ADDENDUM NUMBER ONE (1)
CATAWBA COUNTY
BLACKBURN RESOURCE RECOVERY FACILITY OPERATOR'S BUILDING
PROJECT NO. 26.00701

This Addendum Number One (1) is issued this the 14th day of October 2026, to all parties who hold a set of Bid Documents for the project entitled: **“BLACKBURN RESOURCE RECOVERY FACILITY OPERATOR'S BUILDING”**. This Addendum Number One (1) shall become part of the Contract Documents and its receipt acknowledged on the bid documents at the time of bidding.

3 BUILDING SECTION 3
1/4" = 1'-0"

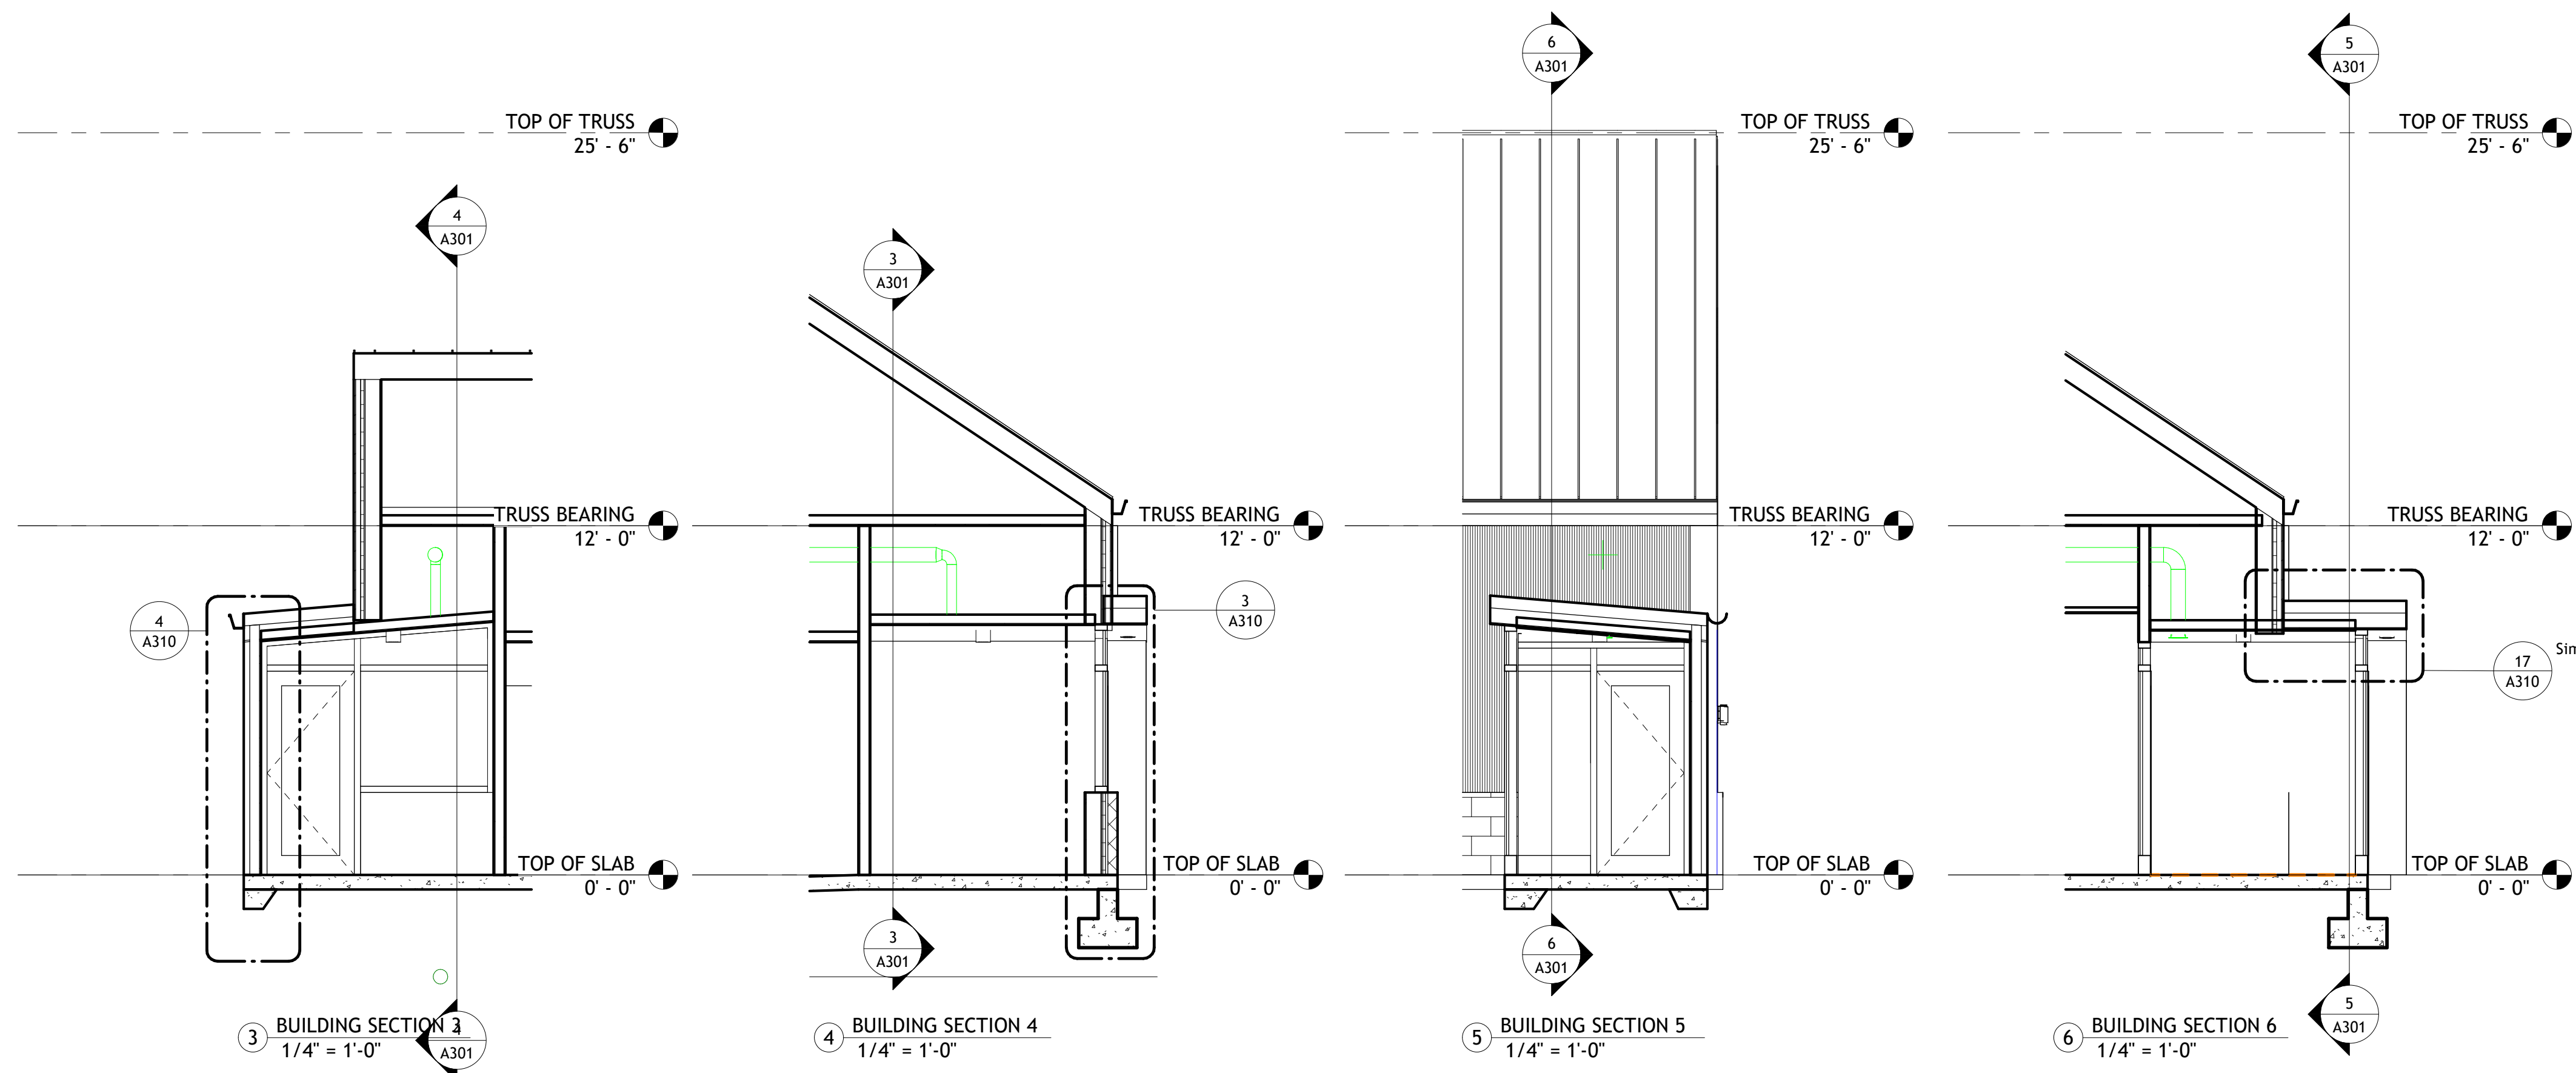
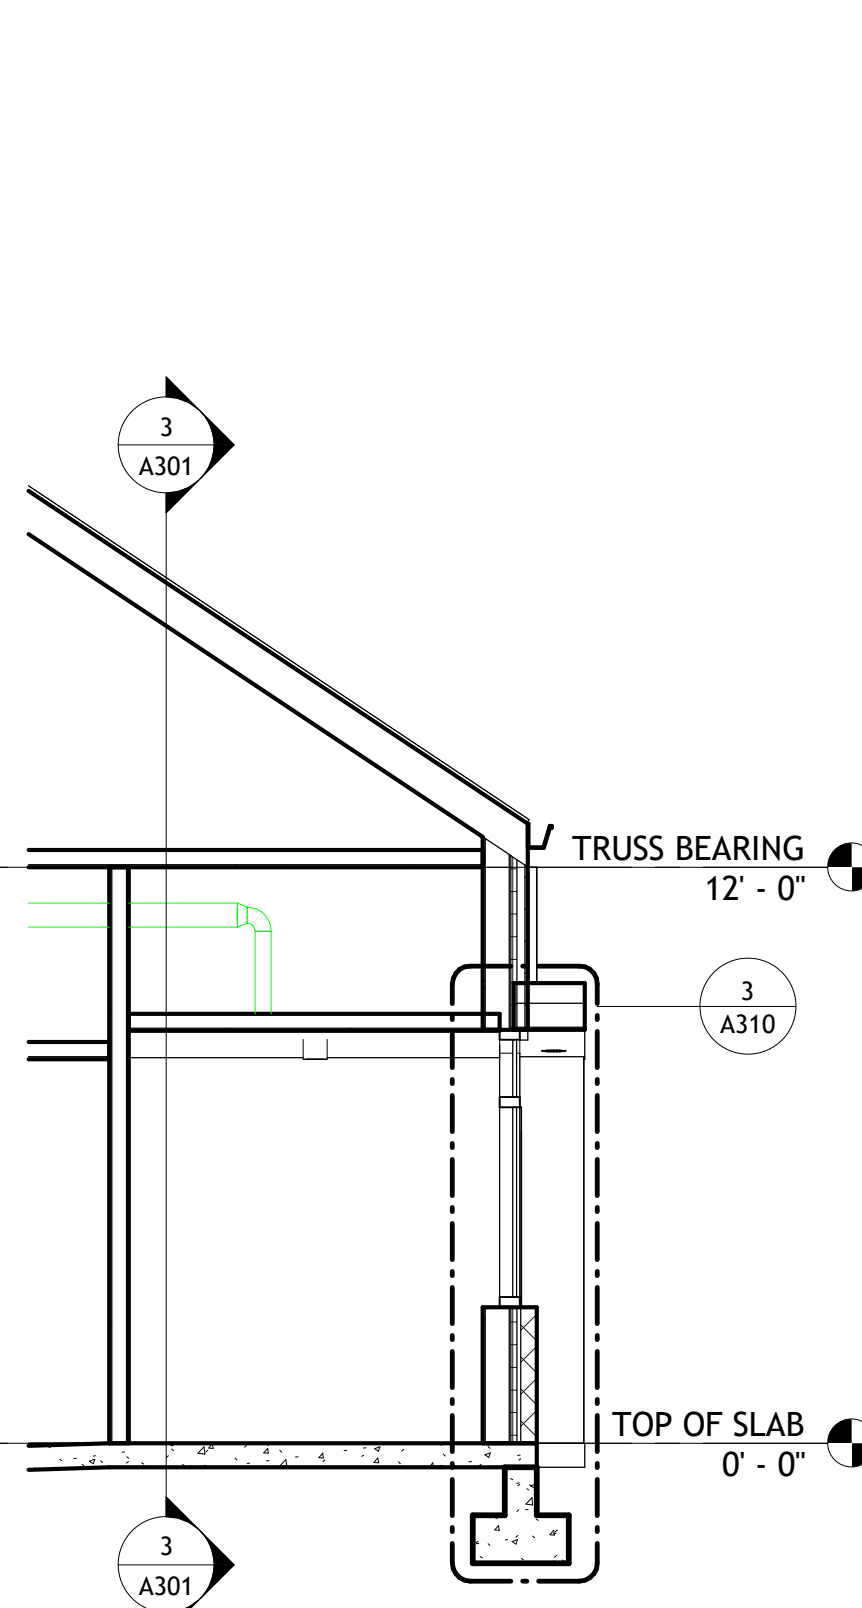
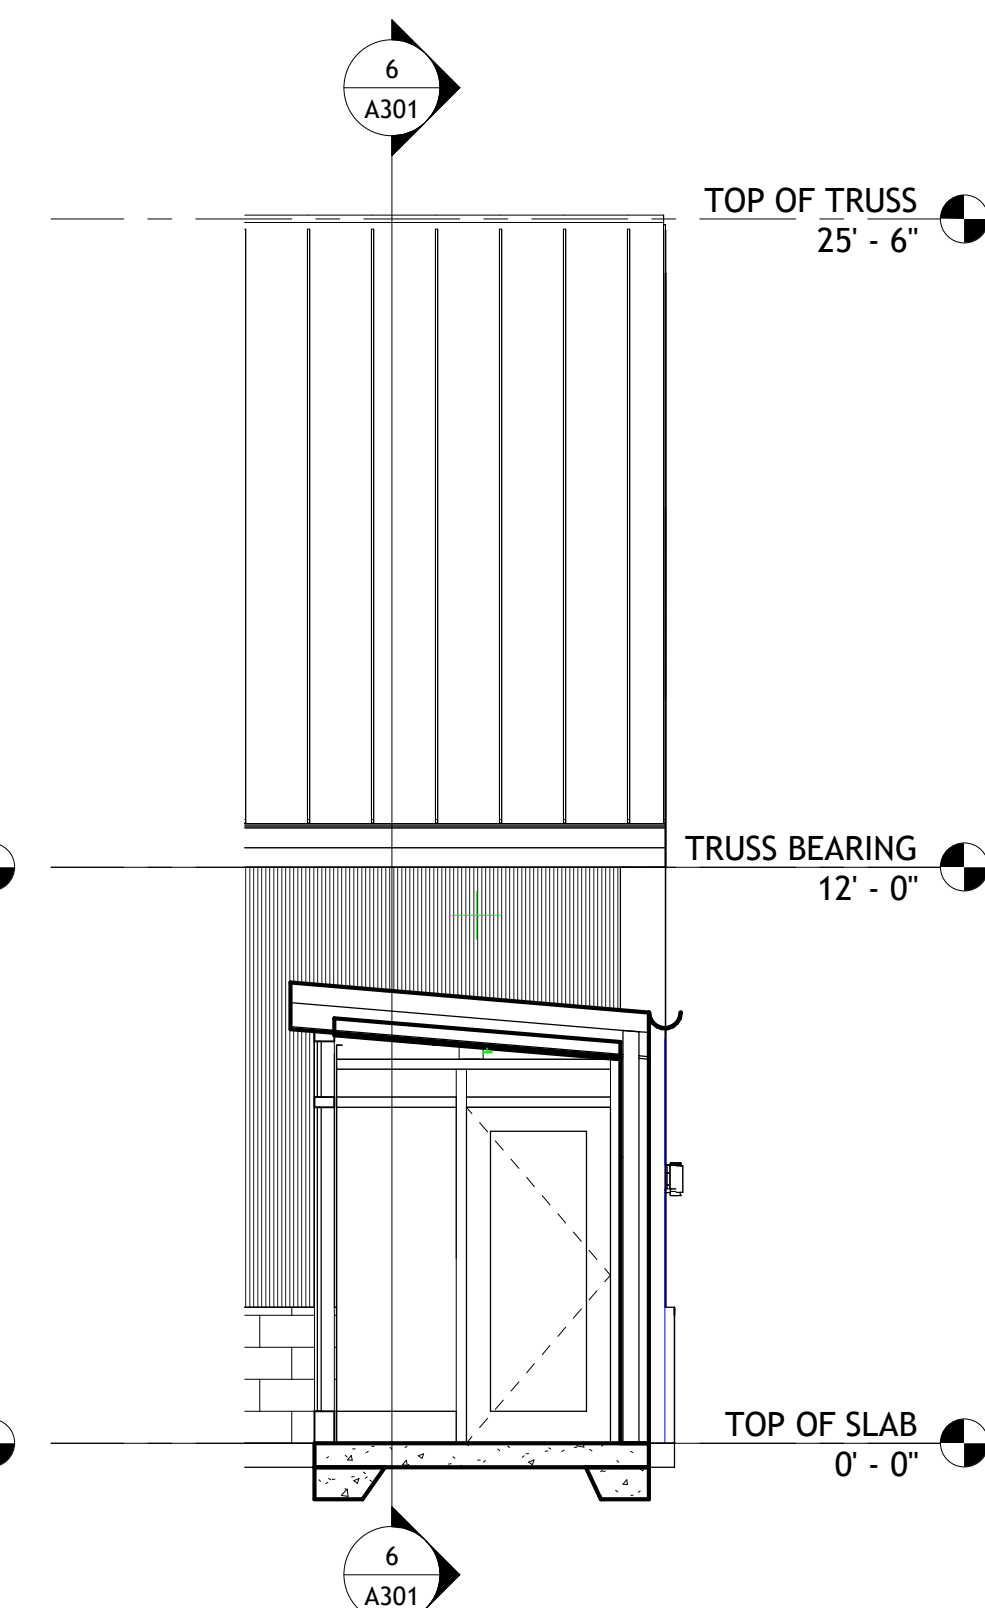
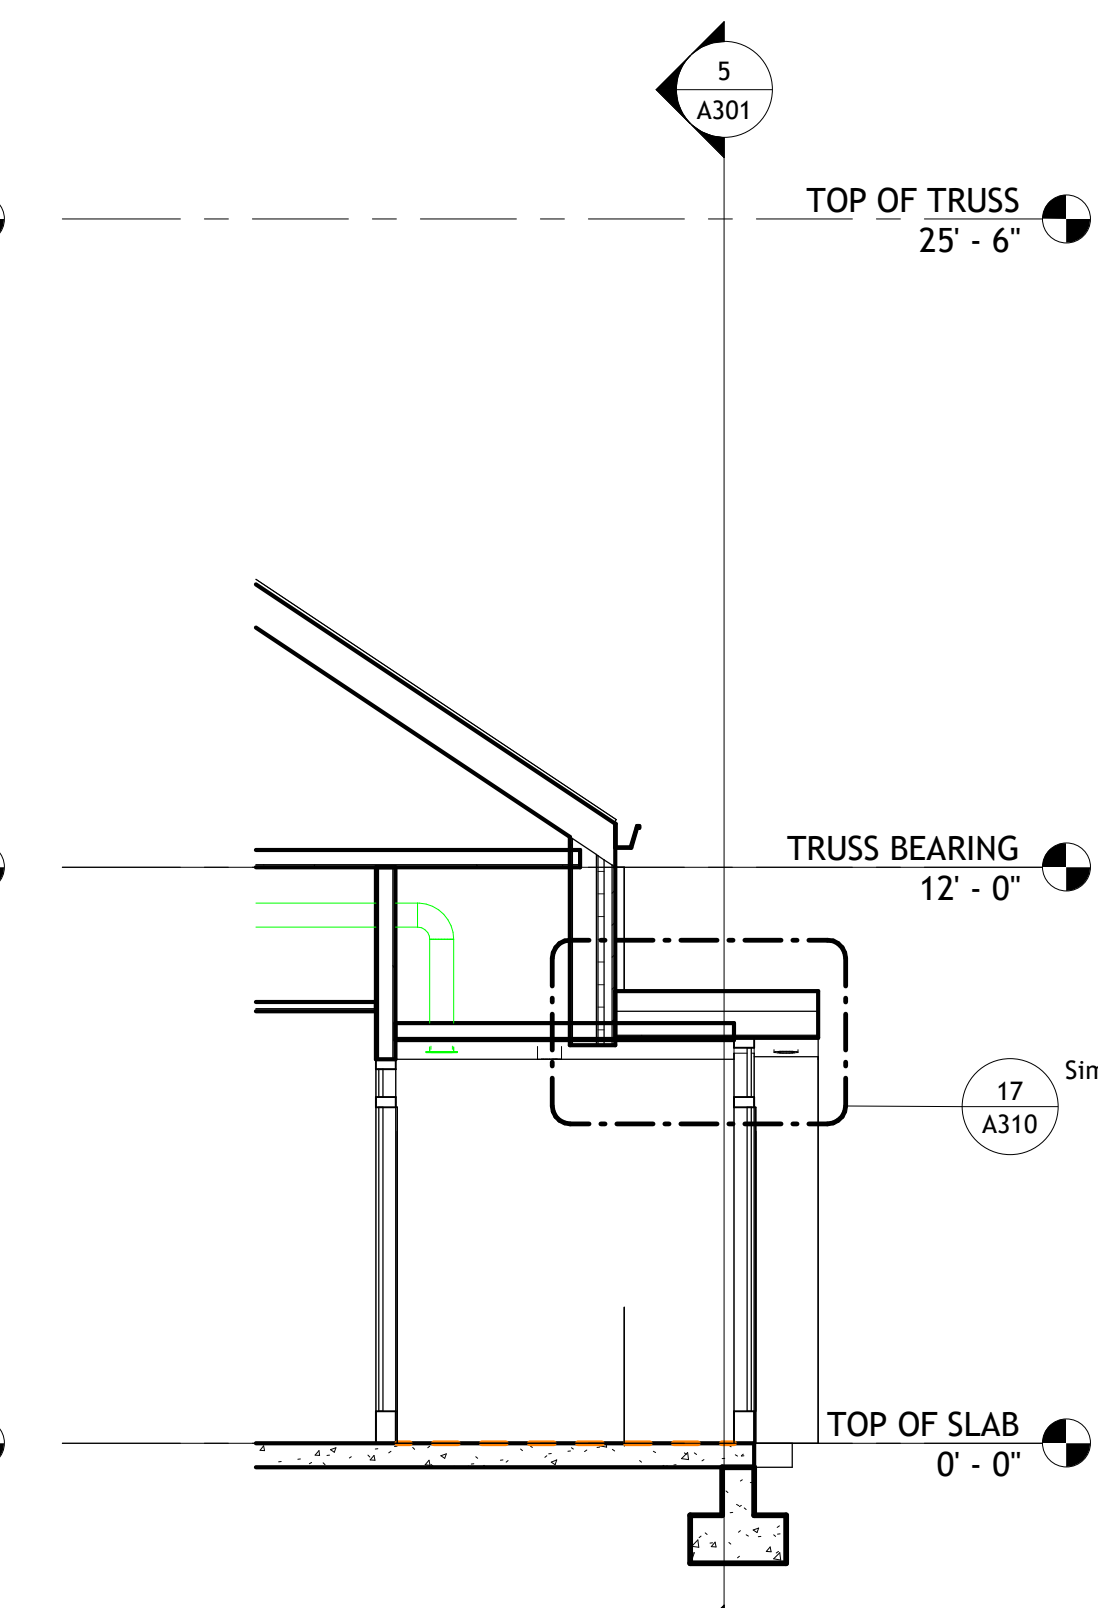
1. Drawings: The below information includes changes, revisions, and updates to the drawings from the original bid set. Please replace the following sheets.
 - a. *Sheet A110*: Revisions made to gutter system and attic insulation types.
 - b. *Sheet A201*: Revisions to gutter system.
 - c. *Sheet A301*: Revisions made to attic insulation type.
 - d. *Sheet A310*: Revisions to gutter system and inclusion of ice and water shield.

- *Will the insulation be blown cellulose or batt insulation in the attic?*

Attic insulation to be batt. Please see revised sheets A110 & A301 in Addendum No. 1.
